## CONSTRUCTION CERTIFICATE APPLICATION ACCESSIBILITY DESIGN COMPLIANCE STATEMENT

**Project Name** Bakaa Cultural Centre

**Project Address** 44 Reid Street, Wilcannia, NSW 2836

# ACCESSIBILITY CONSTRUCTION CERTIFICATE DESIGN REVIEW COMPLIANCE STATEMENT

## Ground Level Plan extract

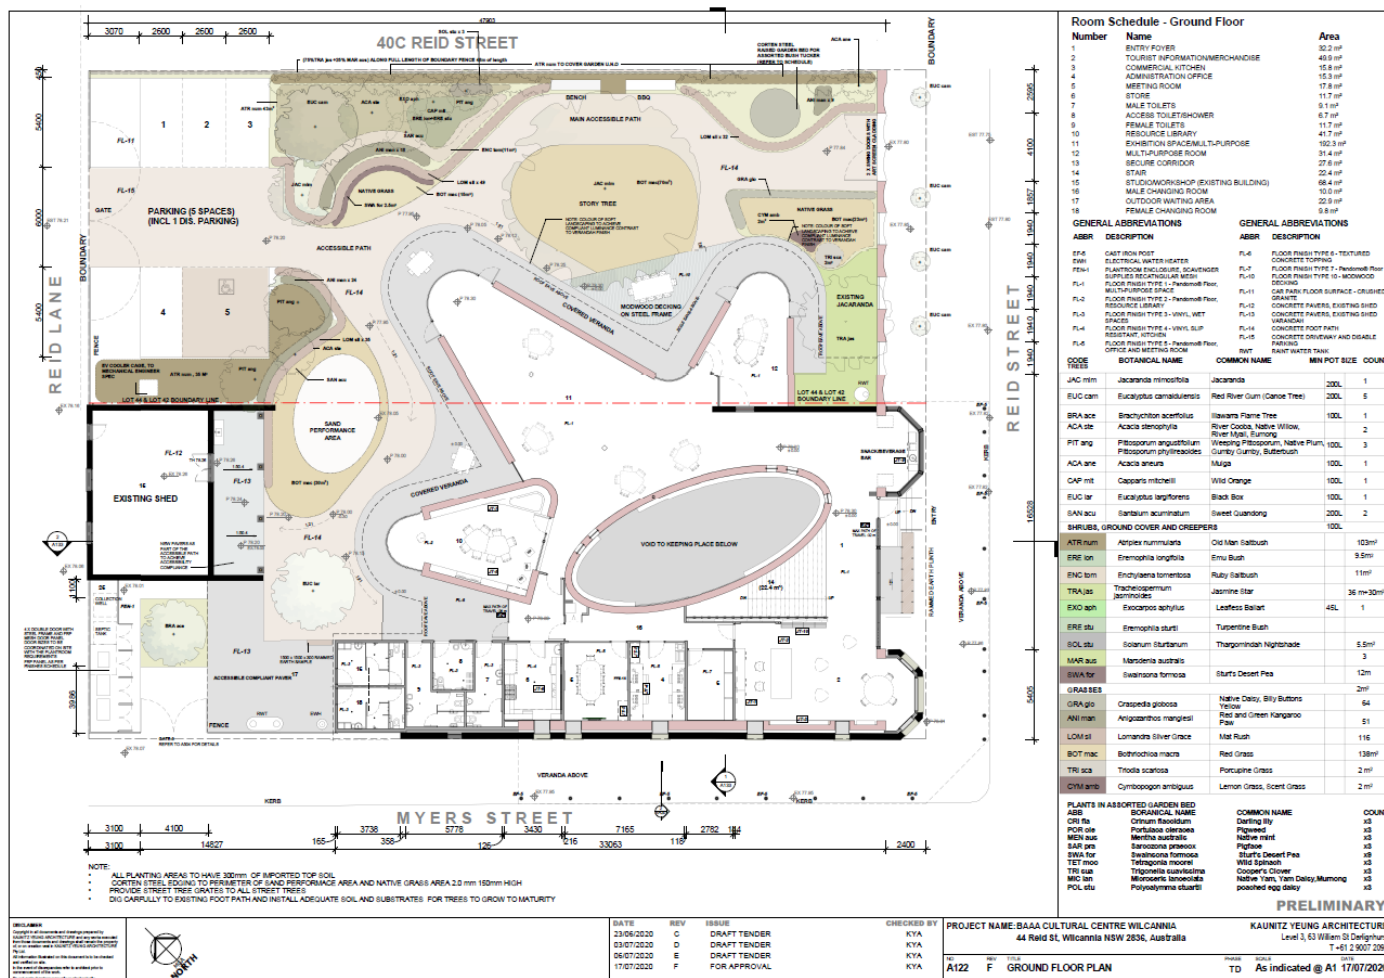
The design has been evaluated against the performance requirements of the BCA, and the Disability (Access to Premises – Buildings) Standards 2010.

The following compliance statement has been prepared for the Bakaa Cultural Centre Wilcannia project design with respect to confirming compliance with the Building Code of Australia 2019 (BCA) and the spirit and intent of the Disability Discrimination Act 1992 (DDA), within the project scope.
